**CITY OF MOUNTAIN VIEW****ENVIRONMENTAL PLANNING COMMISSION  
STAFF REPORT  
JUNE 19, 2019****5. STUDY SESSION**

- 5.2 Study Session to Discuss Proposed General Plan and Zoning Map Amendments, Transfer of Development Rights from the Los Altos School District Site, and Planned Community, Development Review, and Heritage Tree Removal Permits to Construct a 464-Unit Mixed Rental and Ownership Housing Development with Structured Parking and a New 0.4-Acre Public Park Located at 355-365, 401, and 415 East Middlefield Road.**

Figure 5: Site Circulation and Public Access

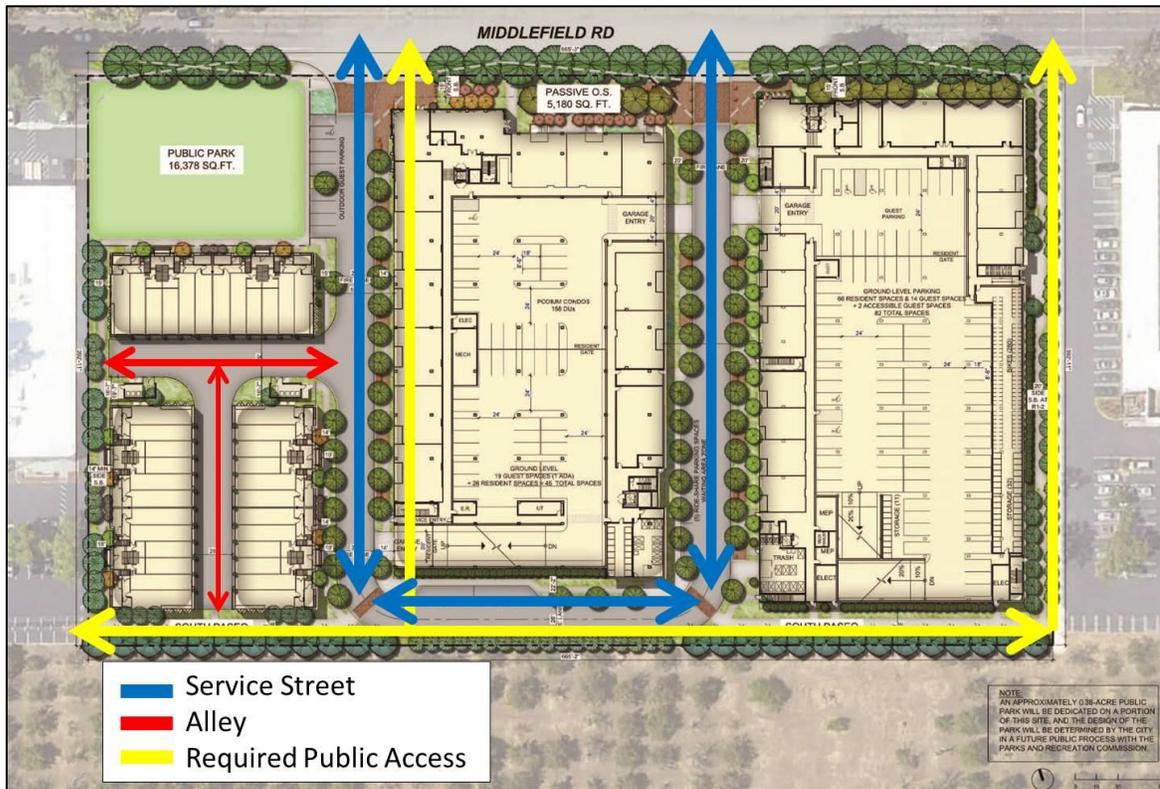
The Draft EWPP requires public pedestrian and bicycle access across development sites to support multi-modal access and smaller block sizes. While the Precise Plan recommends locations for these multi-modal paths based on logical wayfinding and compliance with the block standards, the specific locations or configurations of these connections are not defined in the Plan but are intended to be reviewed as development projects are proposed. The Draft Plan identifies three paths through the project site that are required to provide public pedestrian access, while bicycle access/improvements are encouraged but not required in these locations. Proposed site circulation and required public access are shown in Figure 5.

It should be noted the required north-south pedestrian connection on the left side of the project site (shown in yellow in Figure 5) is intended to provide direct connection to a midblock crossing at Middlefield Road to the northern portion of the Precise Plan area. The current project design places a building in this location, resulting in an offset of the public path to the anticipated location of the midblock crossing. As part of the project review, staff will work with the applicant to determine if any site or building modifications are necessary to ensure a safe pedestrian connection and crossing.

There are two inconsistent aspects of the proposed service street circulation for the proposed project site with the Draft EWPP:

1. *The western portion of the U-shaped service street is 11' to 15' narrower than the EWPP street standards. This results in an overall narrower service street with less sunlight and landscaping due to reduced separation between buildings, which may increase the visual appearance of the seven-story building, affecting both the pedestrian experience and views of the project from the surrounding area.*
2. *The southern portion of the U-shaped service street is approximately 13' narrower than the EWPP street standard and does not provide continuous pedestrian access on both sides of the roadway. As shown along the rear property line, the south*

paseo sidewalk is not continuous for pedestrians requiring them to either walk in the vehicle roadway or cross the street twice. Further discussion is provided below.

As proposed, the project has an incomplete pedestrian circulation network at the rear of the site that brings pedestrians to the interior of the site along either end of the "south paseo" and then requires pedestrians to either cross the service street twice to connect between the paseo segments or walk in the street. The EWPP calls for a pedestrian and bicycle circulation system that encourages active transportation and states all streets within the plan area are "complete streets" to accommodate bicycles and pedestrians with bicycle lanes, wide sidewalks, and enhanced crossings. Staff believes the site design needs to be revised to create a paseo along the southern site boundary that is in conformance with the EWPP and provides direct, convenient, safe, and pleasant walking and biking routes.

***EPC Question No. 1: Does the EPC support the proposed circulation plan exceptions, some lesser extent of the exceptions, or no exceptions?***

**Figure 6: Service Street Design Criteria and Section, Draft EWPP**

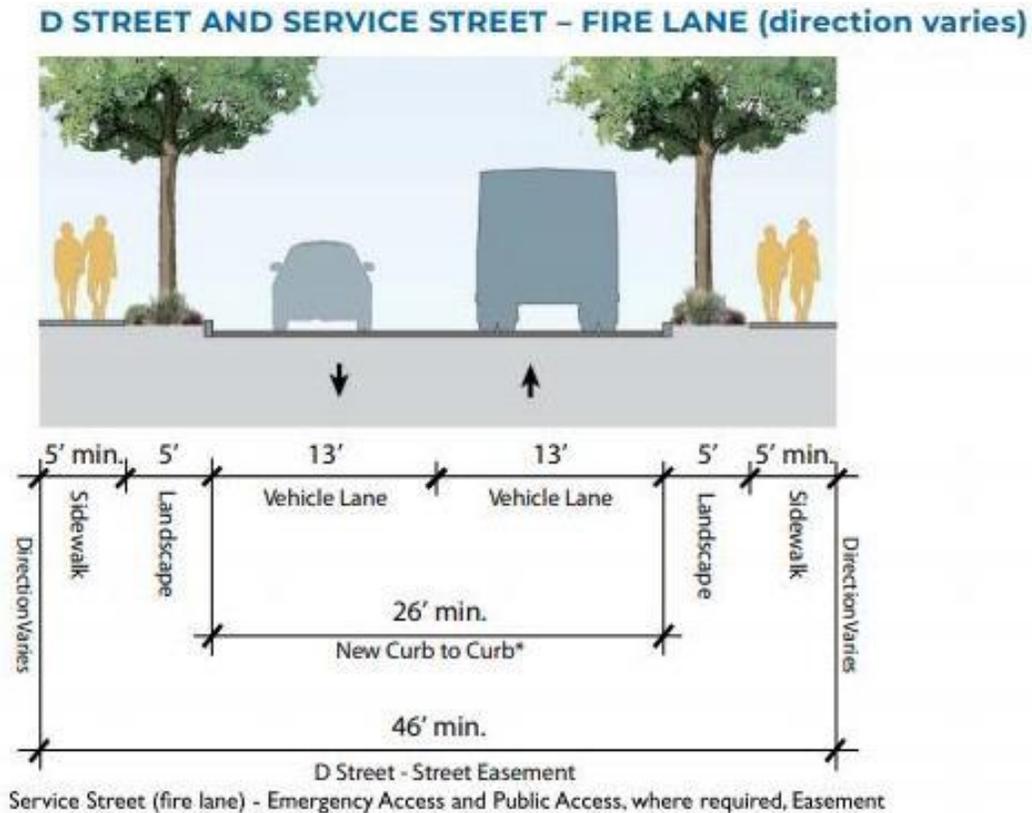
As shown on the Site Plan in Exhibit 4, the east side of the U-shaped service street has a 66' cross-section (between the tallest buildings), while the west side (adjacent to the park) has a 55' cross-section. The EWPP calls for a 66' cross-section for

service streets, including a 26'-wide vehicle roadway, 10' pedestrian zone (including sidewalks and street trees) on both sides of the road, and 10' building setbacks from the back of the sidewalk, as shown in Figure 6 (from Page 141 of the Draft EWPP).
